Council Reference: DA09/0701 LN35979
Your Reference: MP09_0166

Development Application MP09_0166 (Council Reference DA09/0701) - 263 Lot Community Title Residential Subdivision (Department of Planning Application MP09_0166) at Lot 1 DP 169490 & Lot 1 DP 175235 & Lot 1 DP 304649 & Lot 1 DP 781687 & Lot 1 DP 781697 & Lot 40 DP 254416 & Lot 43 DP 254416; No. 37 Fraser Drive BANORA POINT; Lot 2 DP 778727; Parkes Lane TERRANORA

I refer to your letter dated 30 April 2013 in which you invite Council's comment on the Preferred Project Report for Altitude Aspire.

STRUCTURAL SYSTEM PLAN

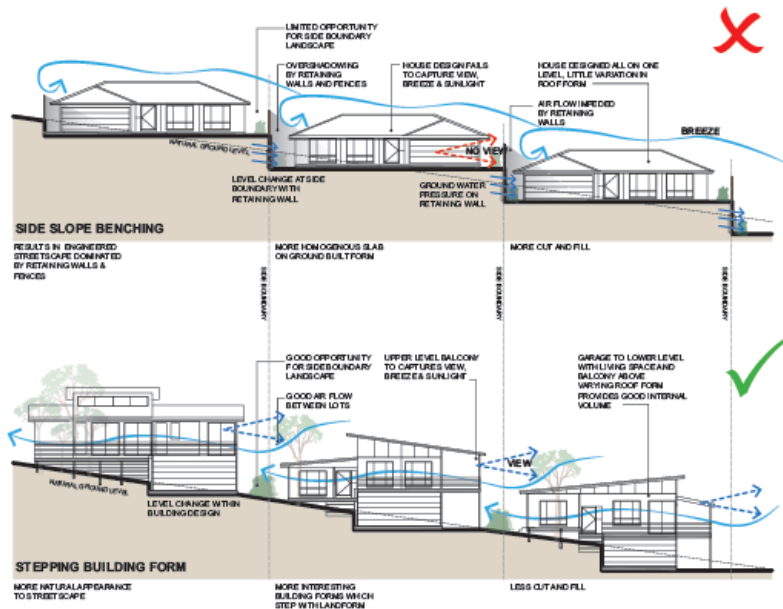
Council staff have serious concerns with the Structural System's Plan as follows:

The above table tries to indicate future house design options dependant on the slope of the allotments. However Council is concerned that it does not clearly reflect the intent of Tweed DCP Section B24.

The use of retaining walls through stages 1, 2, 8 and 9 to create terraced lots is very concerning. These stages possess predominate side slopes of >14% within Stages 1 and 2 and >12% for Stages 8 and 9, which, void of retaining walls, effectively prohibits single slab on ground construction. In this regard, Council is not opposed to exploring methods to accommodate a minor variation however these investigations need to be highly integrated with site works, lot dimensions, relationship with surrounding lots etc. and assessed on a lot-by-lot basis. The extensive use of retaining walls to terrace lots and promote an inappropriate structural system to the extent proposed is not supported.

By way of example, Lots 122 - 128, 201 - 207 and 302 are annotated for Pole Construction, whilst concept design previously canvassed with Council officers and embodied within Annexure 5 (Section 14) display a split slab system. Whilst it is acknowledged that the structural systems are indicative, potentially reconciling this conflict, the table and plan fails

to provide any genuine merit for assessment, or demonstration of an understanding of the design relationship of slope to appropriate construction types.

A Structural Systems Plan should provide an interface whereby the site conditions (i.e. slope, solar aspect etc) correlate with lot size, shape, orientation, land use and structural type to provide a clear context to future development. The submitted Structural Systems Plan is not considered to possess this level of understanding of the site and evidence of that knowledge into subdivision design.

The applicant's structural system plan needs to be reviewed having regard to the below figure from the DCP.

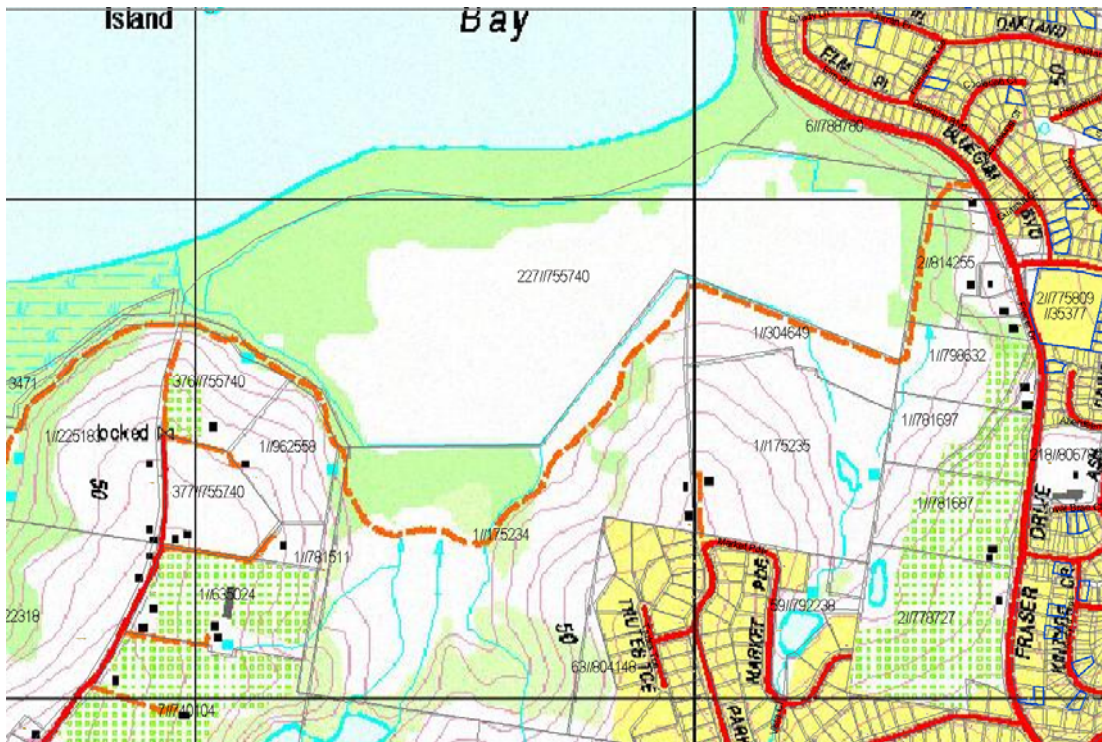
A new road intersection with Fraser Drive will be constructed to provide immediate access to the site, via ‘Road 1’. This is intended to be a temporary connection, until the construction of ‘Broadwater Parkway’ – along the northern residentially zoned portion of the site – is built and extended to Fraser Drive. This temporary connection is capable of adequately servicing the proposed development.

It would be Council’s preference to have the temporary access as a permanent (secondary) point of access for the eastern portion of the ‘Area E’ release area.

This amended submission now also provides an acceptable depiction of the new intersection of Road 9 with Market Parade.

Detail of central drainage corridor (Figure 13, Revised Ecological Assessment (JWA April 2013)). Hatching shows area subject to bulk earthworks, blue indicates existing waterbodies, green indicates Lowland rainforest EEC.

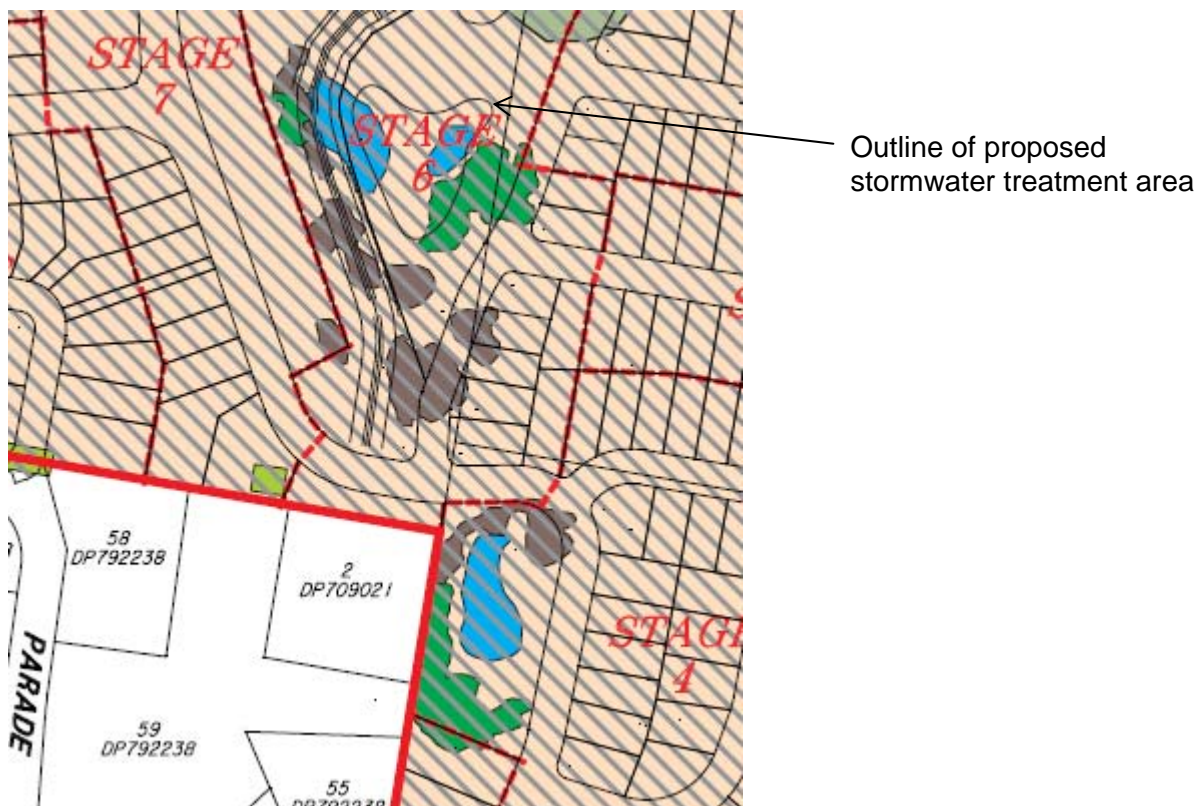
Due to a combination of steep topography, compliance with TSC subdivision requirements in terms of landform, retaining wall heights etc., and the requirement to treat all stormwater within the central gully on the site to reduce impact on the adjacent SEPP 14 wetland, the entire development footprint will be subject to some form of earthworks.

The removal of remnant Lowland Rainforest EEC patches and the filling of existing waterbodies in order to fulfil development open space requirements adjacent to proposed Stage 4 is not supported.
